Broadcast Products Technical Bulletin 20-2004-106

SUBJECT: NO RED OR BLUE COLOR ON SCREEN

MODEL: ***BVM-D9H1A***
BVM-D9H1E
BVM-D9H1U
BVM-D9H5A
BVM-D9H5E
BVM-D9H5U

Figure 1

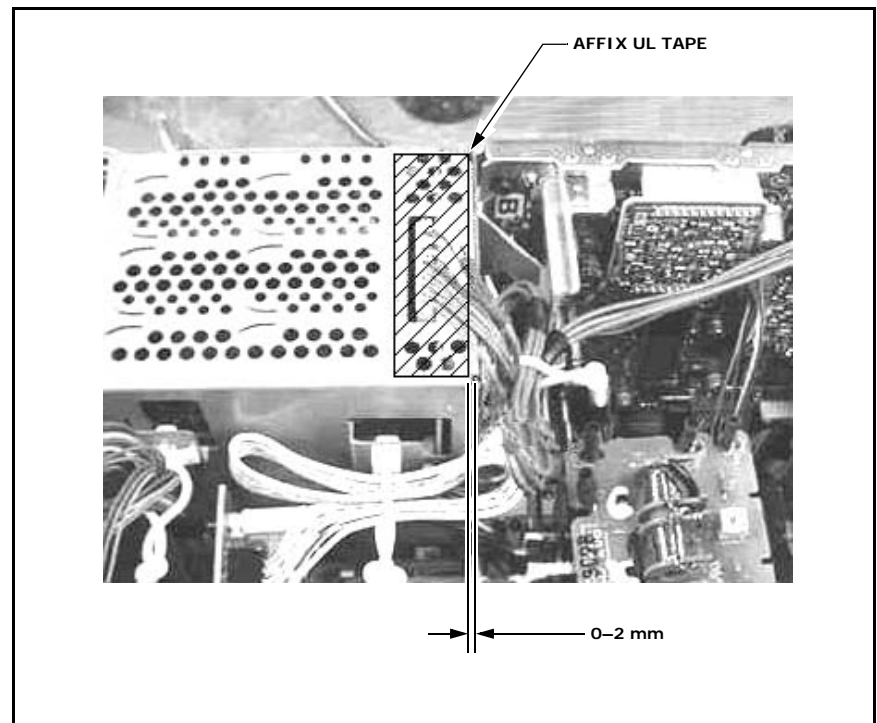
Red or blue color may not appear on the screen.

This symptom occurs if the harness from CN801 on the T board is positioned inappropriately and becomes pinched or damaged by the top cover when closed.

To protect the harness from the edges of the ventilation holes on the top cover, affix UL tape as shown in Figure 1.

NOTE: Ensure that the tape does not overlap the top edge of the cover.
